### SANS 1083 ASPASA Review Where to from here?

# Pertinent updates to share from ASPASA review

#### Additional Aggregate grading proposal for Concrete

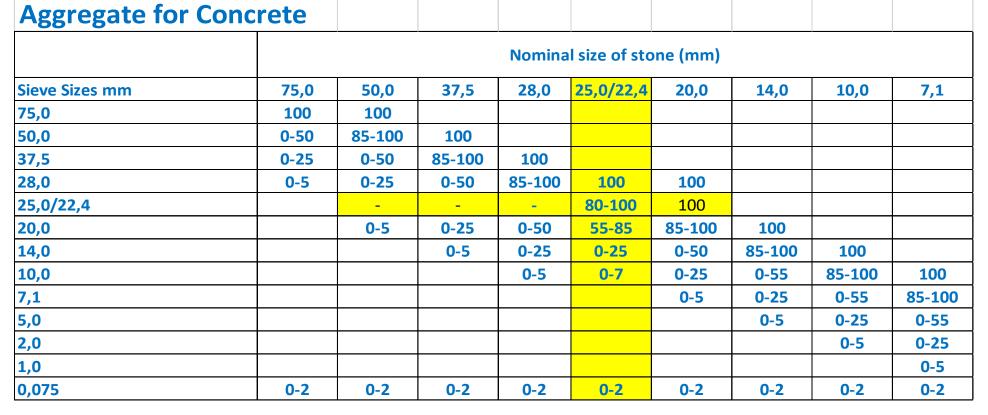
- Request for the inclusion of 22,4 mm/25 mm concrete aggregate.
  - Benefits include improved throughput, improved shrinkage values, improved water demand, improved flexural strengths, optimized concrete mix designs based on improved performance and available historical performance data with various rock types.
- Inclusion of Slag Aggregate for use in concrete
  - Need to define the testing regime.
- Synergy to be established between COTO, SABITA Manual 35 and SANS 1083 so that there is alignment across all applicable design specification.
